ADDENDUM NO. 1

September 1, 2022

CROWN POINT HIGH SCHOOL ATHLETIC FIELDS AND SITE IMPROVEMENTS
Crown Point, IN 46307

SHEET
C-4.1

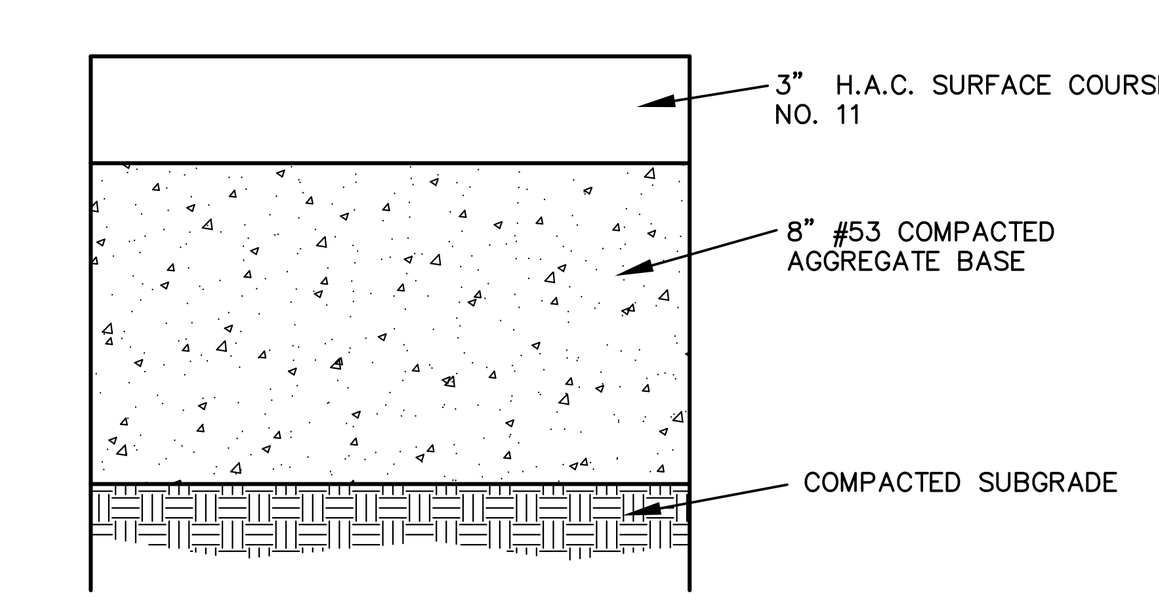
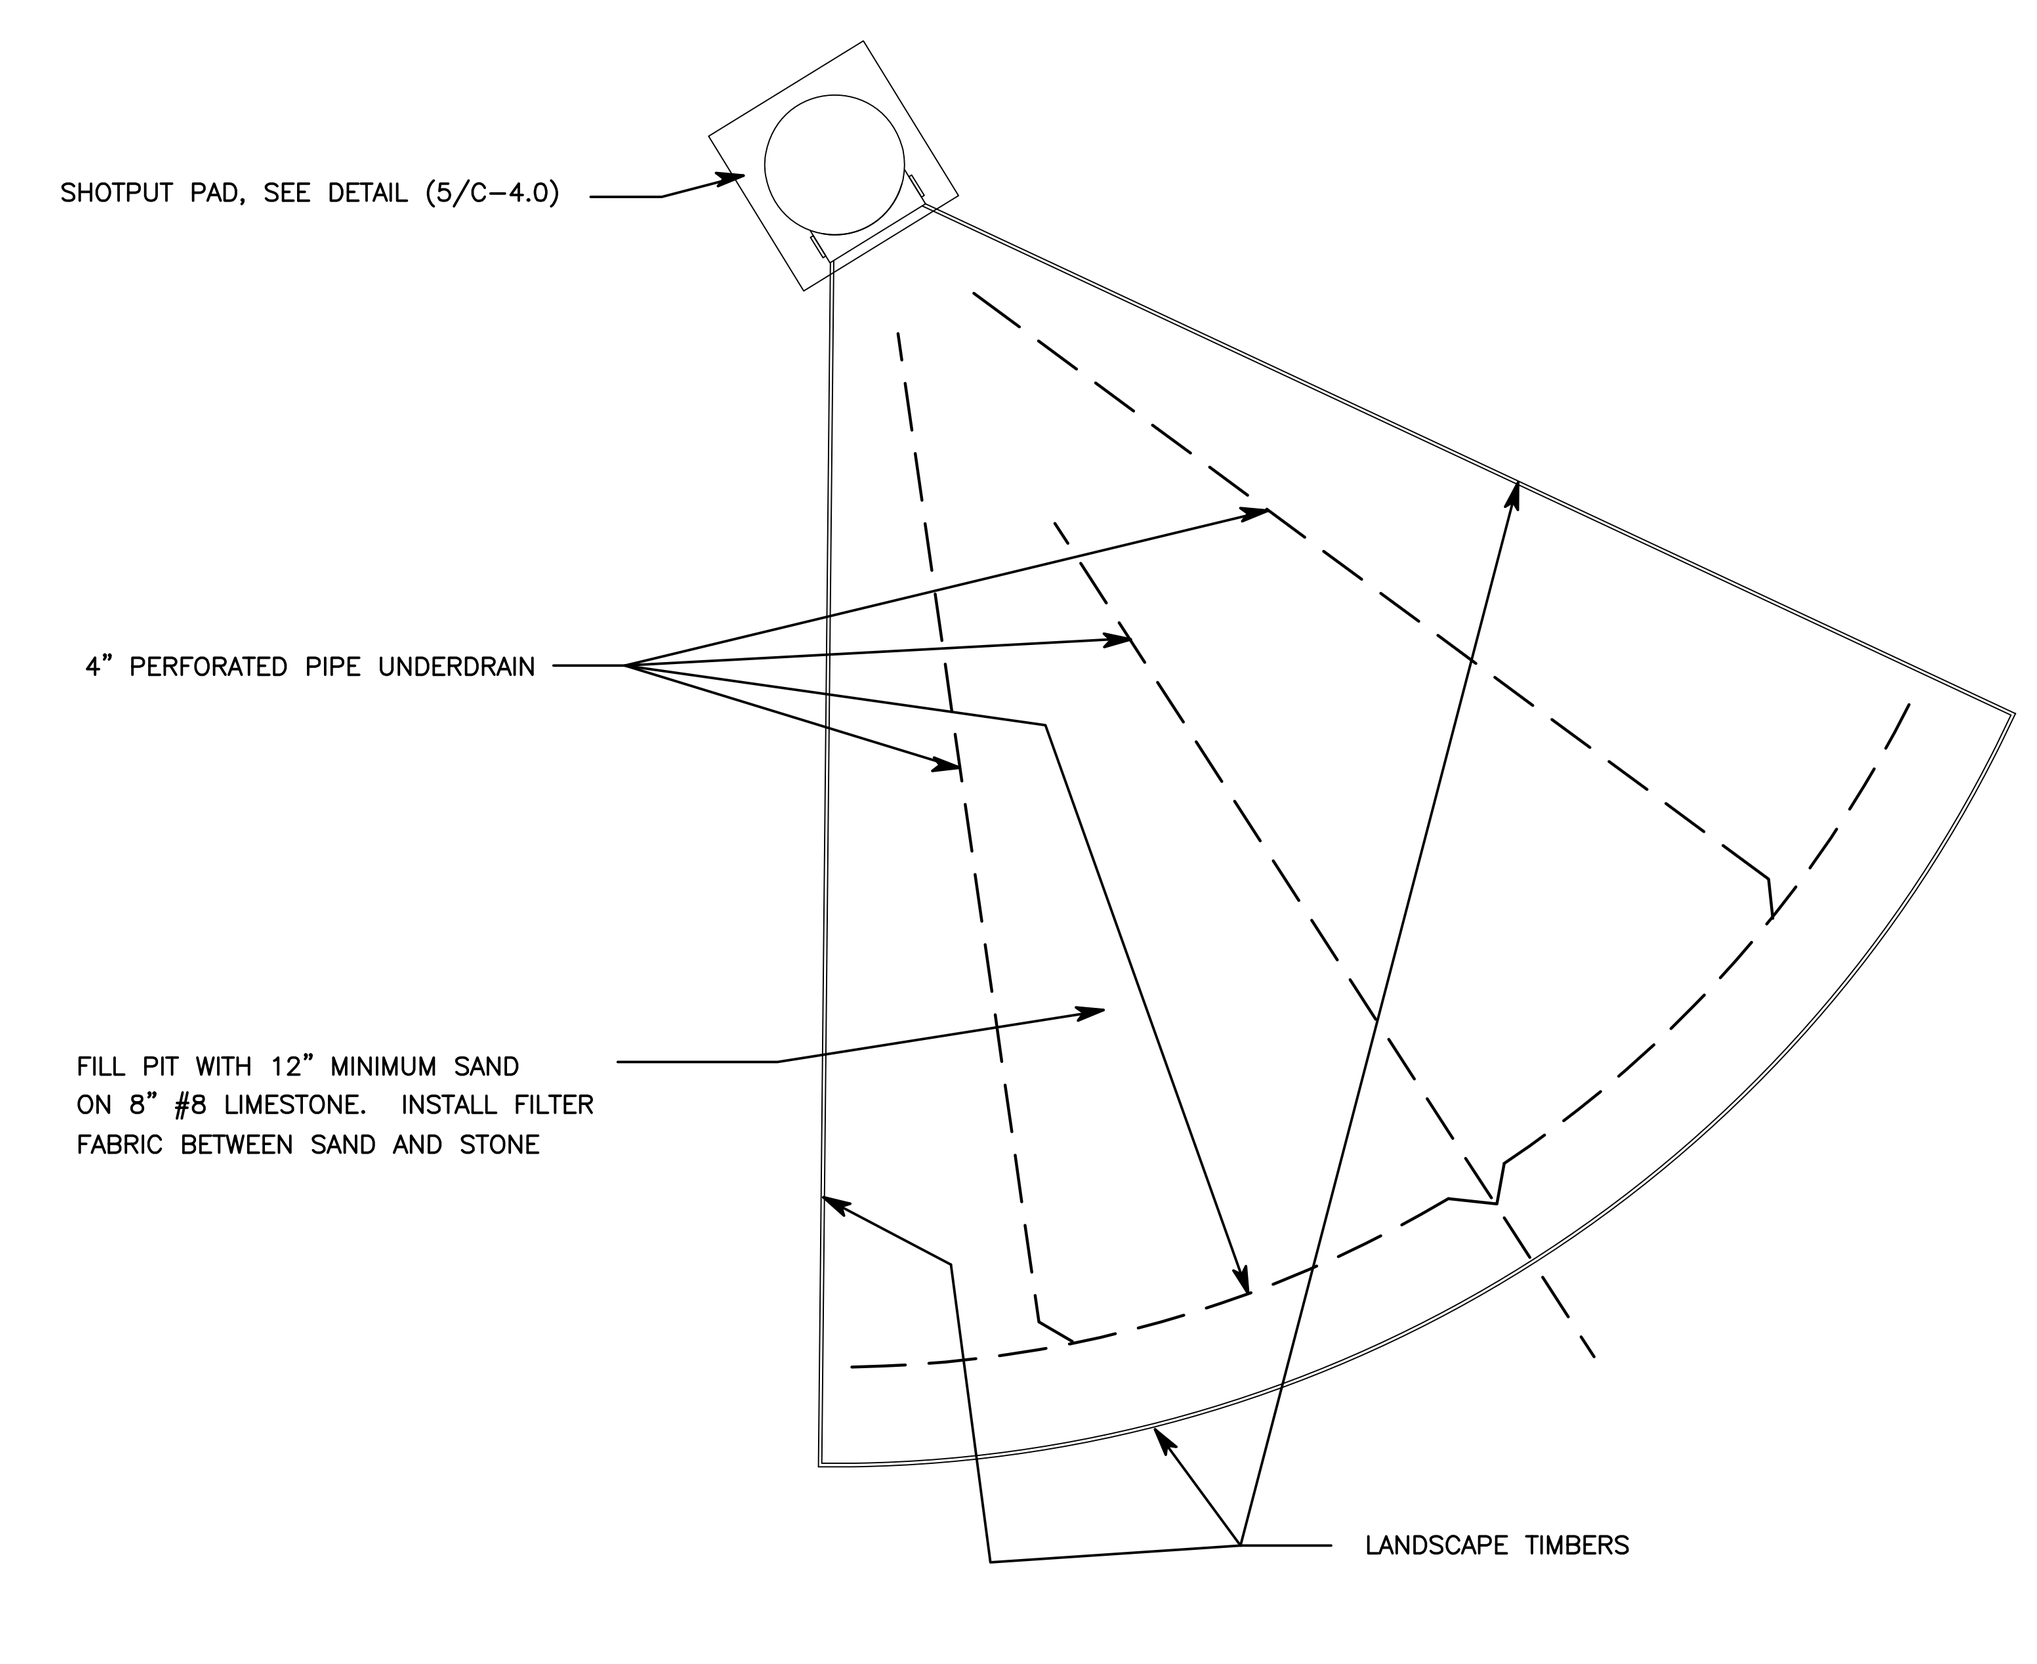
A. Refer to revised, full-size drawing, included in this Addendum, for added shotput and asphalt pavement details.

3
C-4.3

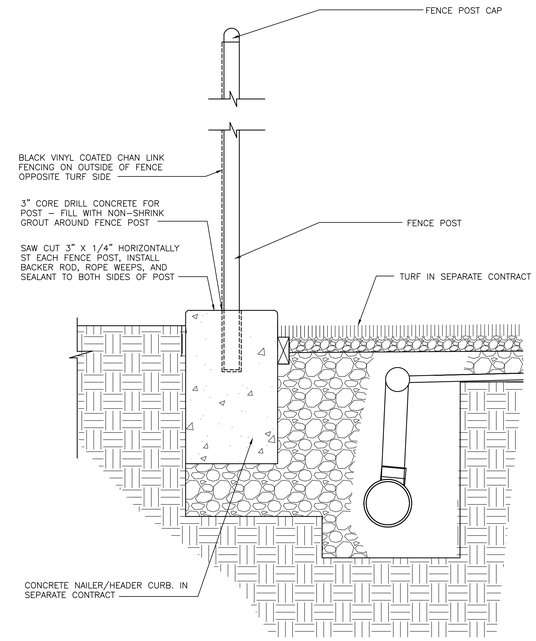
A. Refer to revised, full-size drawing, included in this Addendum, for revised Detail 3/C-4.3 as indicated on drawing.

SHEET
S-100N

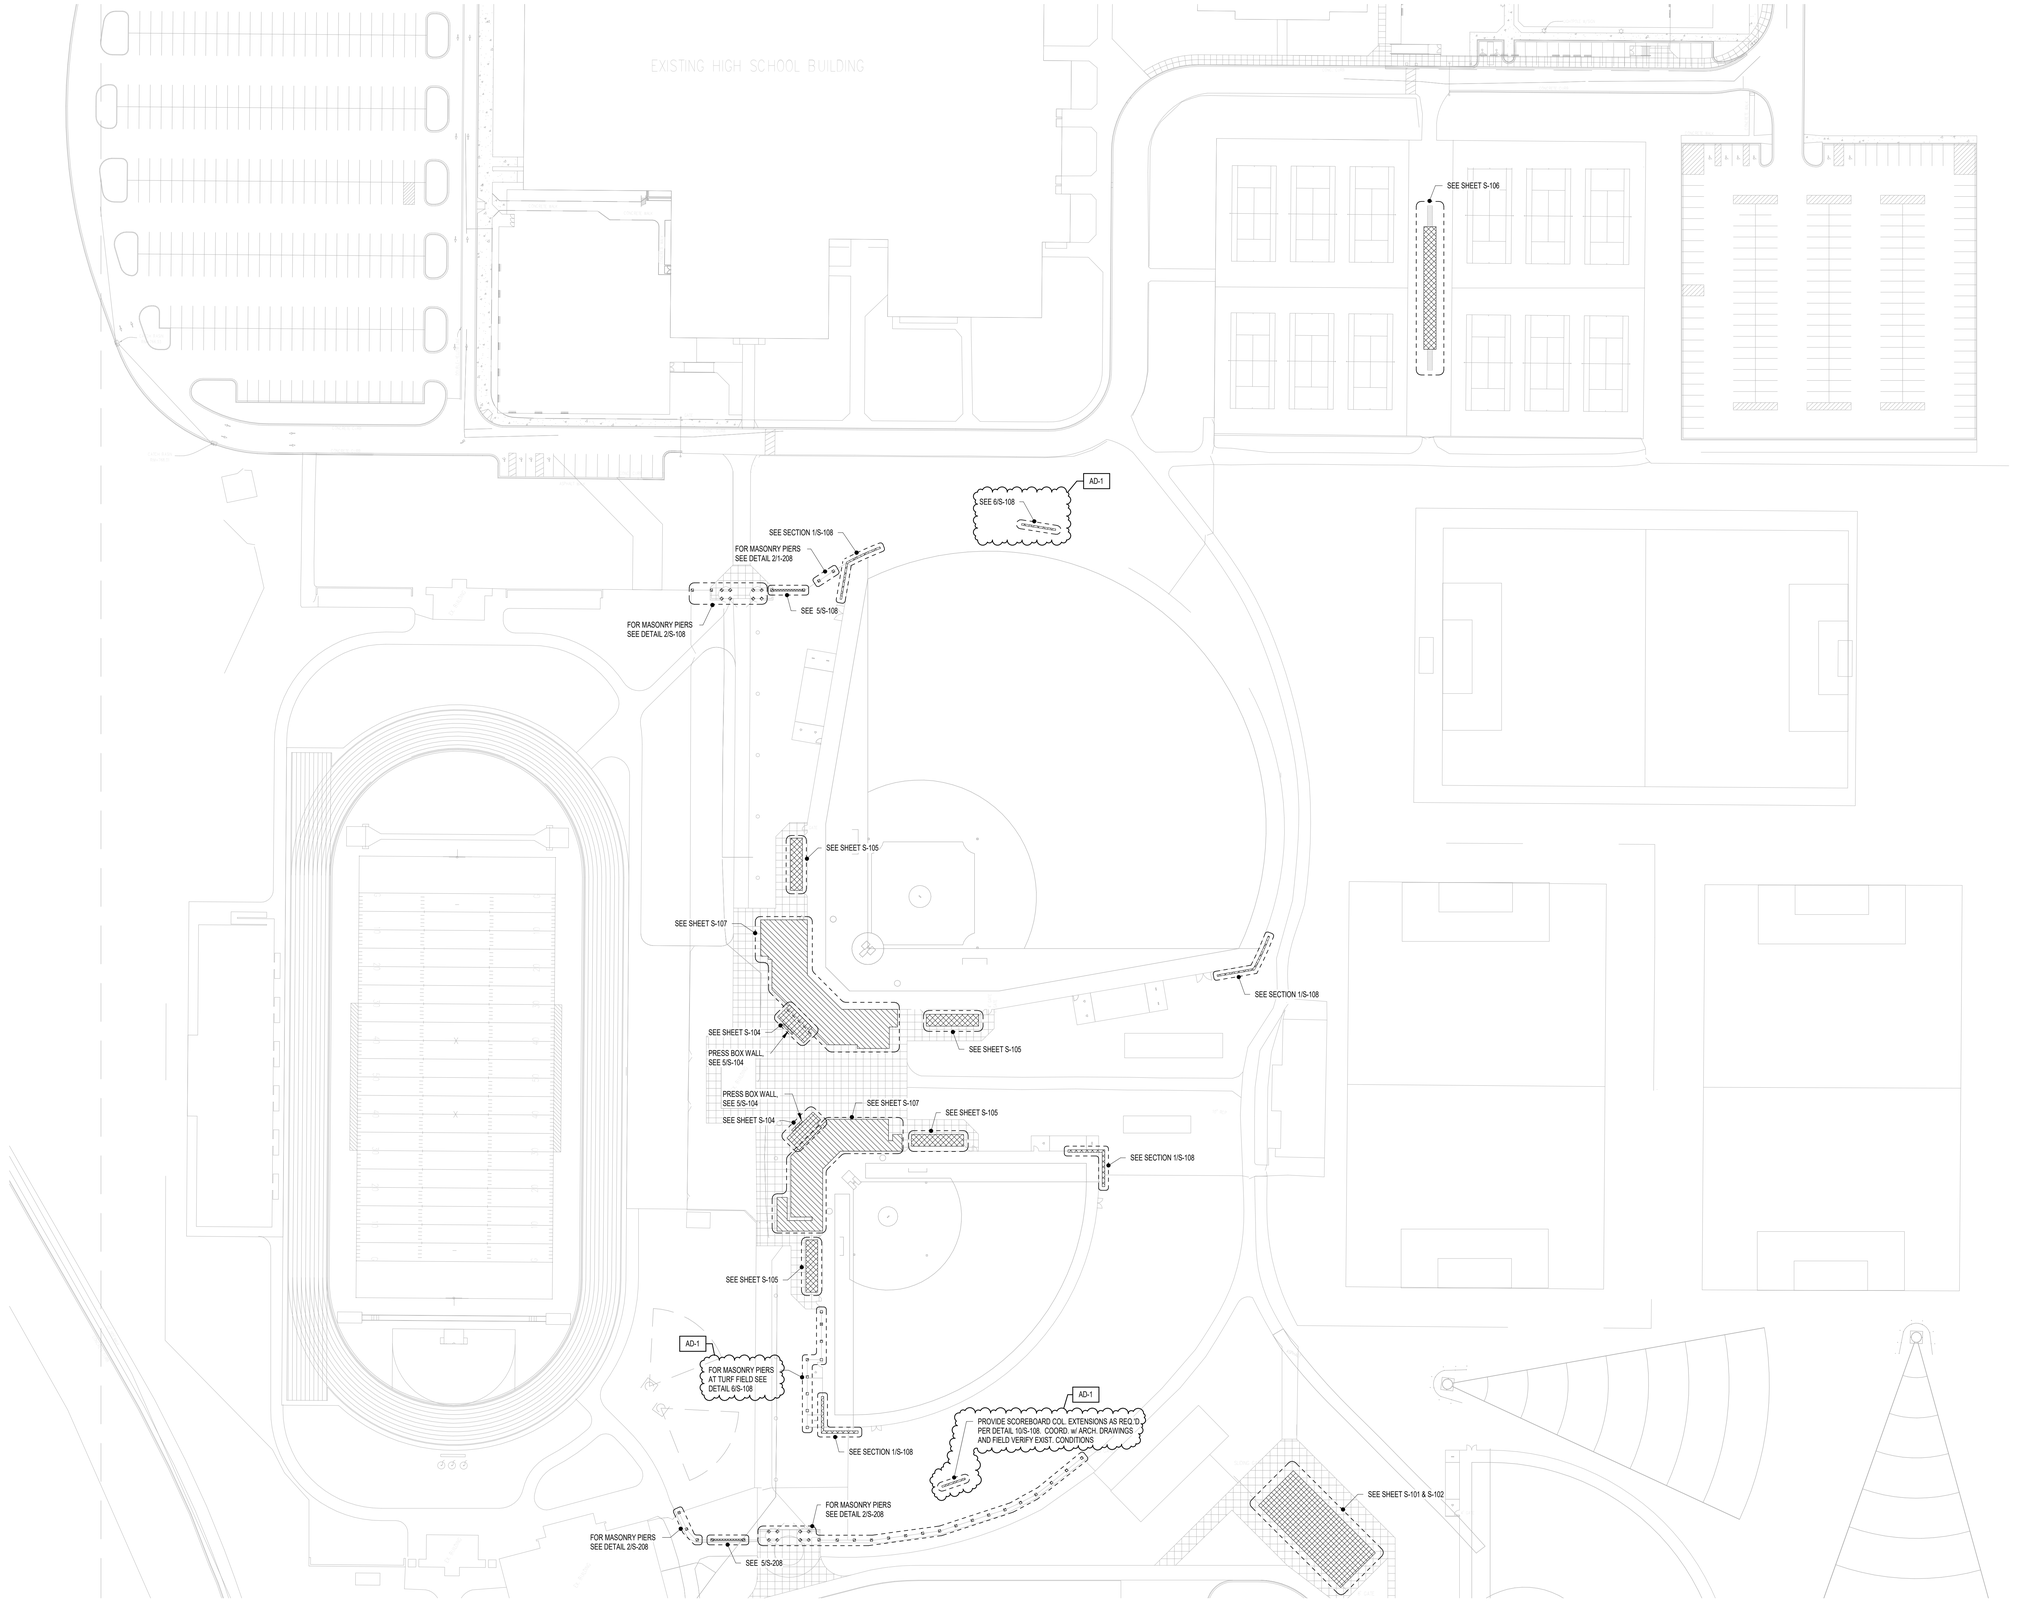
1. References to scoreboards added for baseball and softball field.
2. Masonry pier detail reference updated for piers at softball field.

SHEET
S-100S

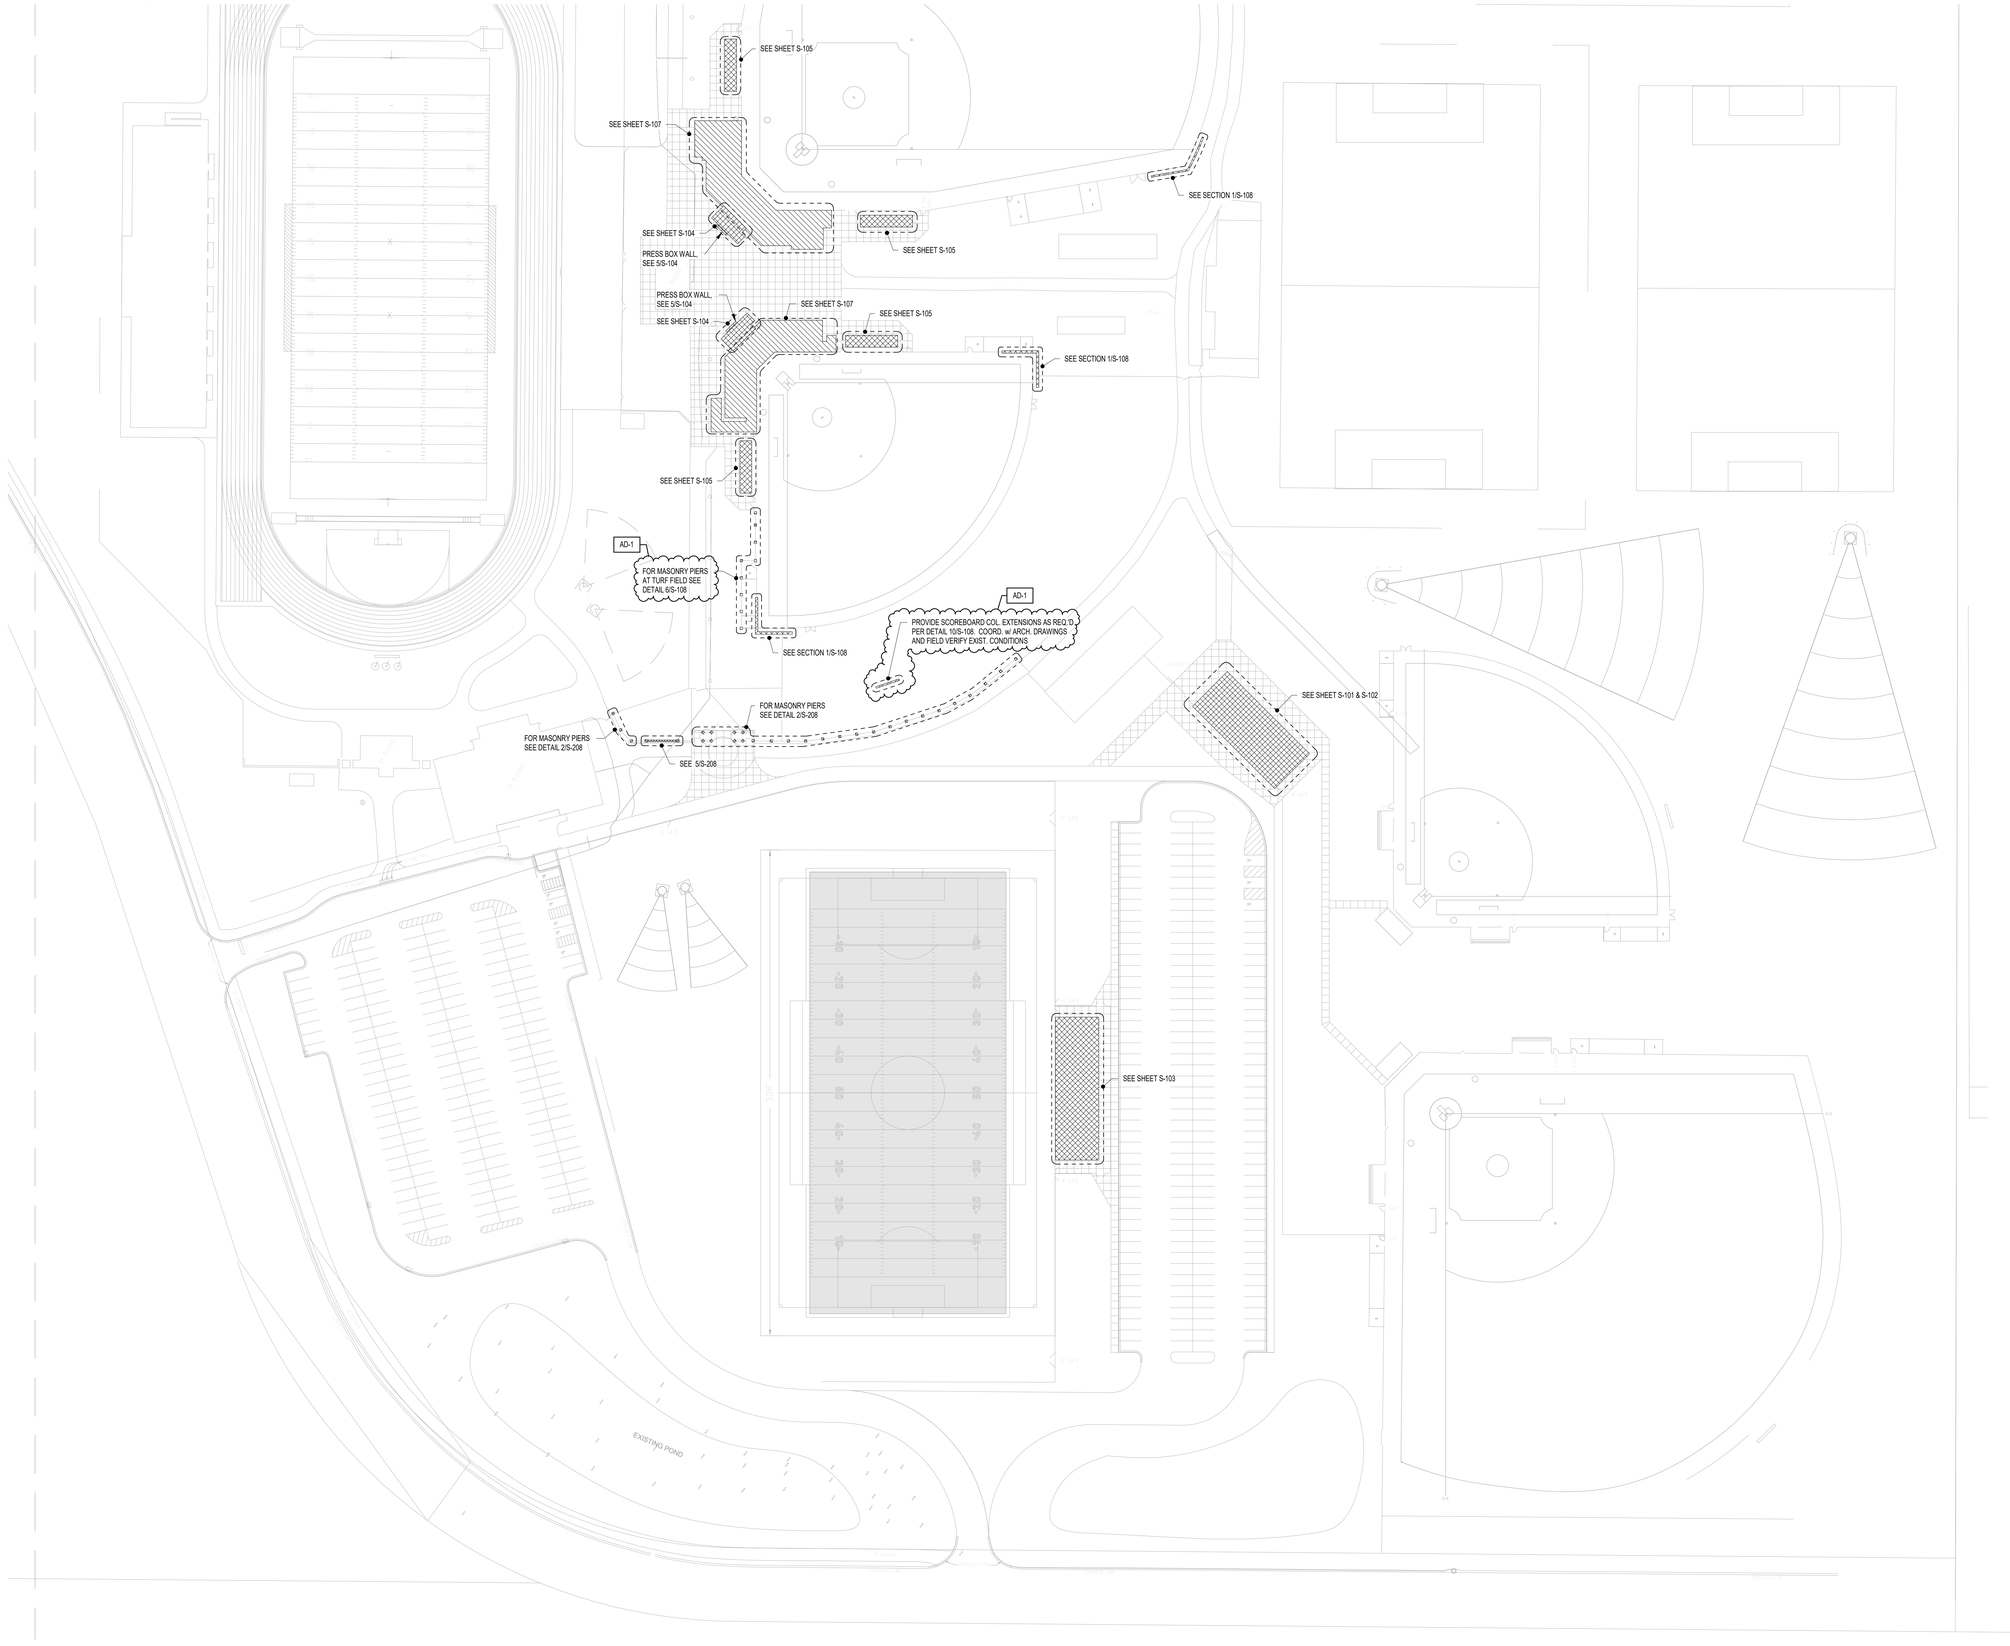
1. References to scoreboards added for baseball and softball field.

7 FRAMING SECTION
1" = 1'-0"

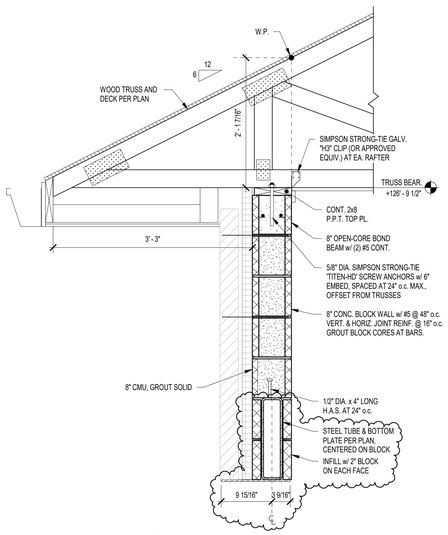
A. Refer to revised, full-size drawing, included in this Addendum, for Detail 7 adjusted to show 2" block on each side of tube lintel.
